**SUBJECT: SURRY NUCLEAR PLANT – NRC OPERATOR LICENSE EXAMINATION
REPORT 05000280/2017301 AND 05000281/2017301**

Report No.: 05000280/2017301 and 05000281/2017301

FACILITY POST-EXAMINATION COMMENTS AND NRC RESOLUTIONS

Item #11: RO Written Exam Question #53

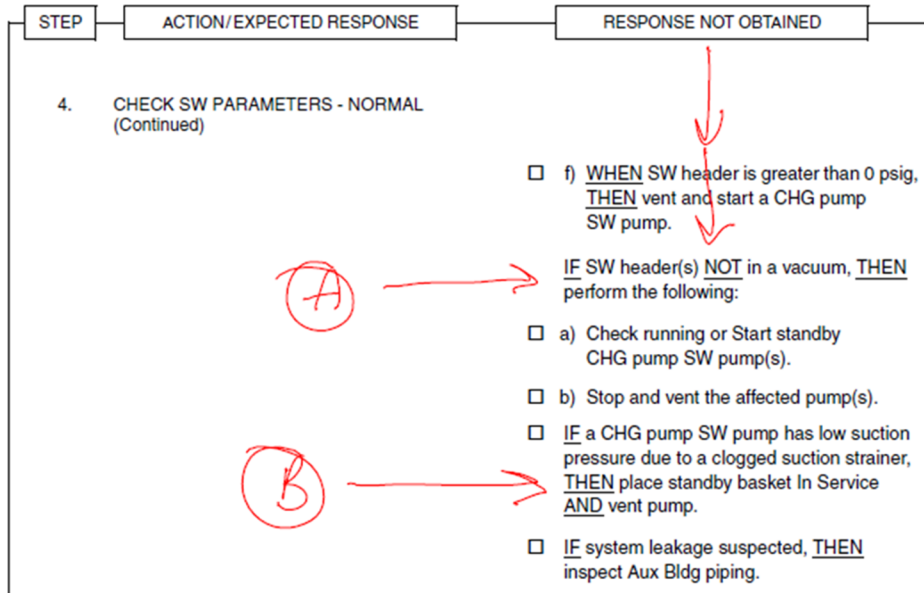
Two applicants contended that answer choice 'B' is also correct, because the sub-steps in Abnormal Procedure 0-AP-12.00, Service Water System Abnormal Conditions, Step 4 RNO are not bulleted and therefore can be performed in any order.

The facility agreed that choice 'B' is also correct, and provided the following marked-up page from the procedure, with subsequent justification:

Sub-steps (marked “A” and “B” above) are of the same level of indent and although “A” is the more appropriate action, “B” contains corrective actions for this scenario. It would be reasonable for a team, performing a scenario with the given conditions, to choose either the “A” or “B” path.

Placing the standby strainer basket in service would correct the issue presented by the question, and is procedurally allowed (the “B” option above). It appears that the question writers and Chief Examiner were focused on pump 1-SW-P-10B not auto-starting as designed, and the most direct and quickest way to remedy the situation would be to start the ‘B’ CHG Pump SW Pump from the main control room (the “A” option above). But locally swapping strainer baskets, while taking more time, would restore normal operating conditions to the ‘A’ pump, so the start of ‘B’ would no longer be necessary.

Therefore, Answer Choice ‘B’ is also correct, so **two correct answers** were accepted for Question 53: ‘B’ and ‘C’
